WARRANTY BULLETIN SAFETY CAMPAIGN

CAN-AM® ROADSTER

Subject: ▶ **Non-Compliance: Headlights Replacement -- Headlights may Shine Too High** ◀

No. **2017-2**
REVISION 1
May 31st 2017

HEADLIGHTS TO REPLACE

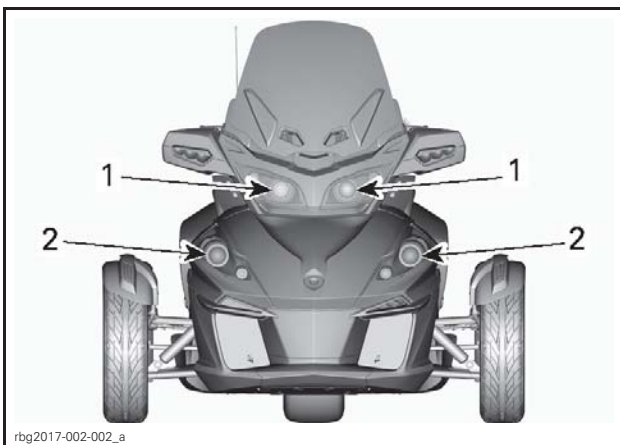
Replace headlights.

Adjust headlights. Refer to the *2013 SPYDER SHOP MANUAL*.

HEADLIGHTS TO REPLACE

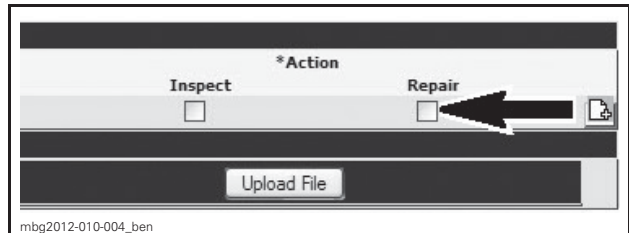
Replace headlights.

Adjust headlights. Refer to the *2013 SPYDER SHOP MANUAL*.
